The Commission has issued the enclosed Amendment No. 17 to Facility Operating License No. DPR-67 for St. Lucie Unit No. 1. The amendment consists of changes to the Technical Specifications appended to License No. DPR-67 in response to your applications referred to in the following paragraph.

ST. LUCIE PLANT UNIT NO. 1

Amendment No. 17
License No. DPR-67

SAFETY EVALUATION BY THE OFFICE OF NUCLEAR REACTOR REGULATION

FIGURE 3.4-2a

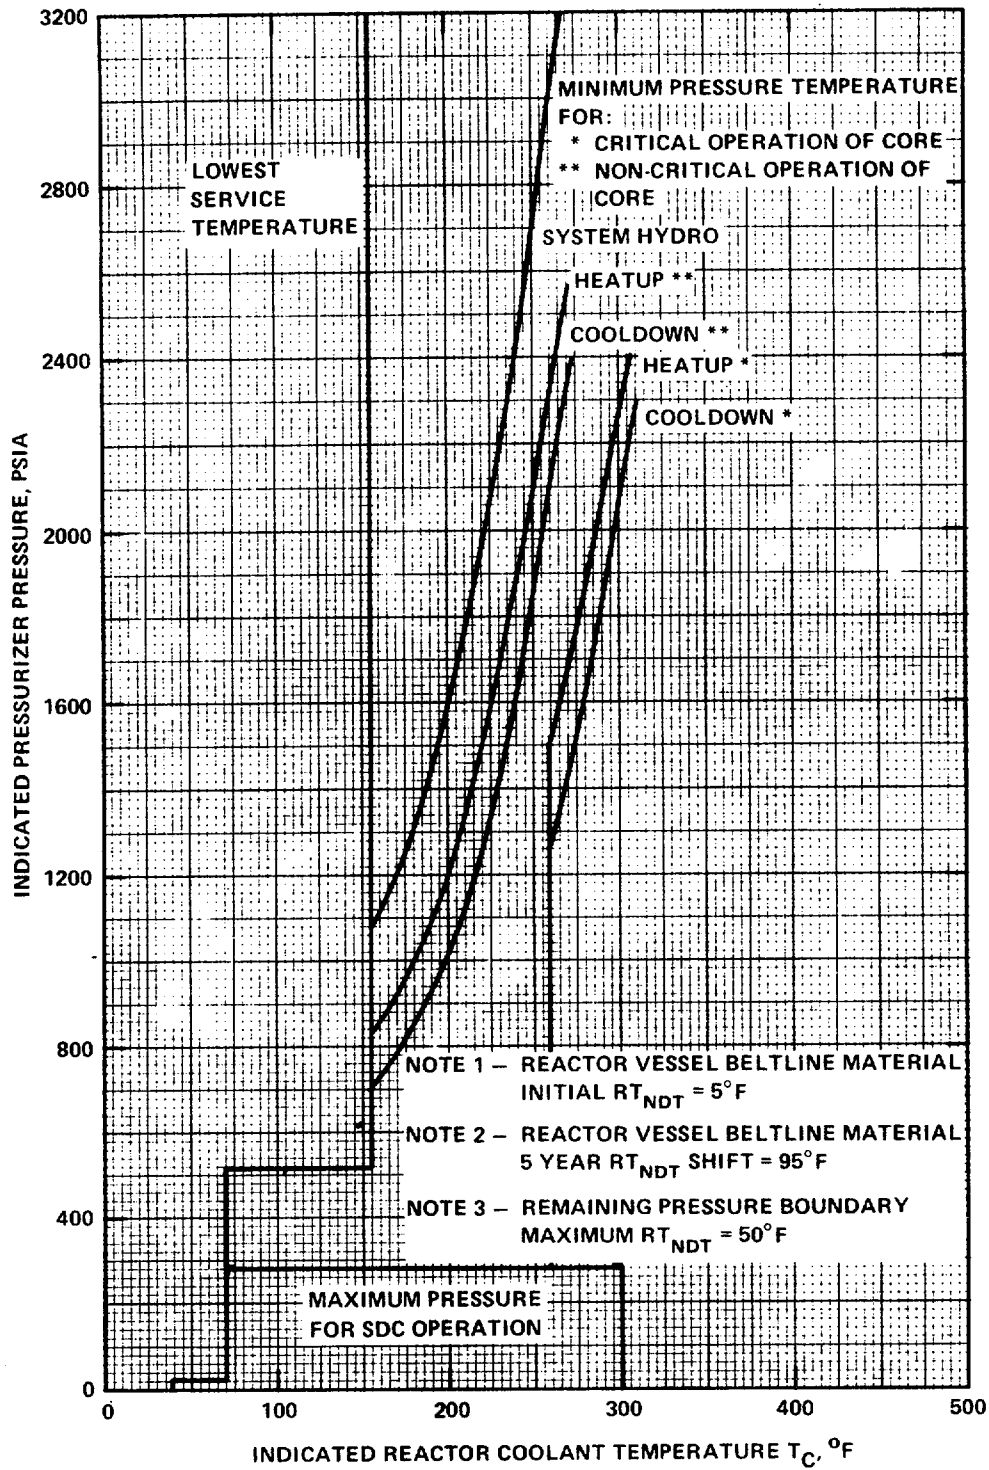
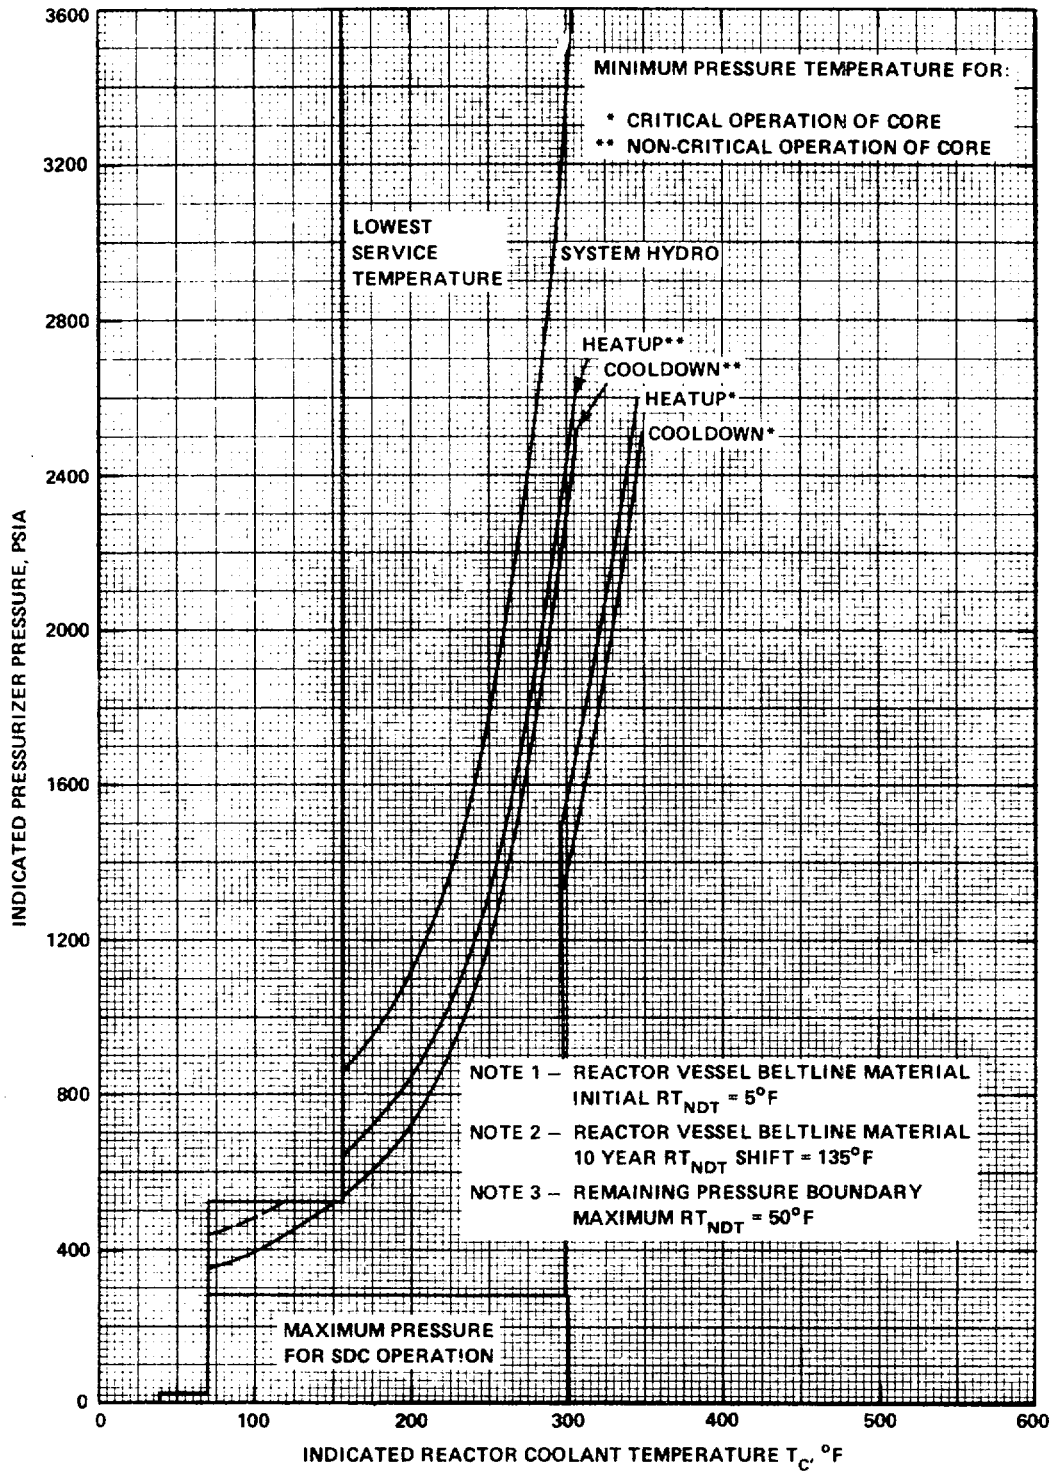
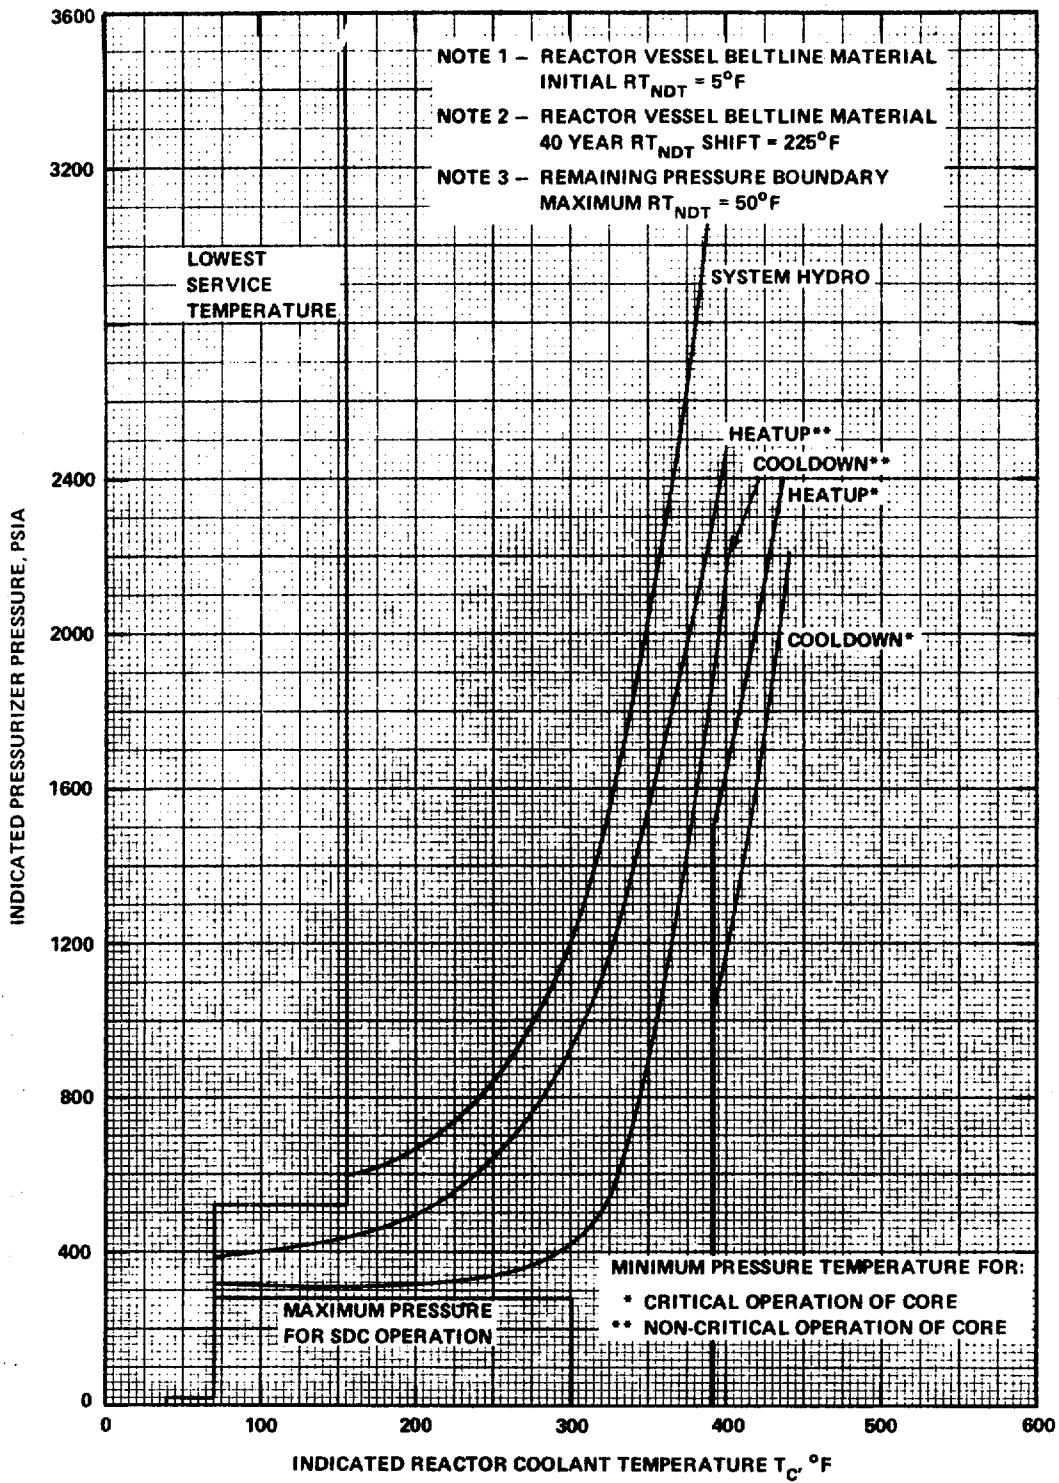
3. provides new figures ("Reactor Coolant System Pressure Temperature Limitations") to comply with Appendix G of 10 CFR Part 50, in accordance with your application dated March 17, 1977 (L-77-82),

3. provide new figures ("Reactor Coolant System Pressure Temperature Limitations") to comply with Appendix G of 10 CFR Part 50, in accordance with your application dated March 17, 1977 (L-77-82),

On February 15, 1977 the NRC staff notified FPL that the original Reactor Coolant System Pressure Temperature Limitations for St. Lucie Unit No. 1 may not comply with paragraph IV.A.2.b of Appendix G, 10 CFR Part 50. Appendix G, Paragraph IV.A.2.b requires that high stressed regions, such as nozzles, have margins of safety comparable to margins for shells remote from discontinuities.

For the FPL proposed operating limit curves, the beltline materials are assumed to have a reference temperature (RT_{NDT}) equal to 100°F at 5 effective full power years (EFPY). Because the maximum initial value of RT_{NDT} of the remaining vessel materials is 50°F, the limiting RT_{NDT} is 50°F higher than the RT_{NDT} of all higher stressed regions. This complies with the requirements of Branch Technical Position MTEB 5-2, which is attached to Standard Review Plan 5.3.2, "Pressure-Temperature Limits," and is an acceptable means of complying with paragraph IV.A.2.b of Appendix G, 10 CFR Part 50.

We have reviewed the proposed operating limits included in FPL's letter dated March 17, 1977, as Figure 3.4-2a for up to 5 EFPY and conclude that Figure 3.4-2a complies with Appendix G, 10 CFR Part 50 and is acceptable. Conformance with Appendix G in establishing safe operation limitations will ensure adequate safety margins during operation, testing, maintenance and postulated accident conditions and constitute an acceptable basis for satisfying the requirements of NRC General Design Criterion 31, Appendix A, 10 CFR Part 50. FPL also submitted pressure temperature limits for operation to 10 EFPY and to 40 EFPY. These curves appear to be acceptable. However, the NRC staff will defer final evaluation of these curves until additional radiation information is provided by FPL in accordance with requirements of Technical Specification 4.4.9.1.c based on reactor vessel material irradiation surveillance specimen examinations.
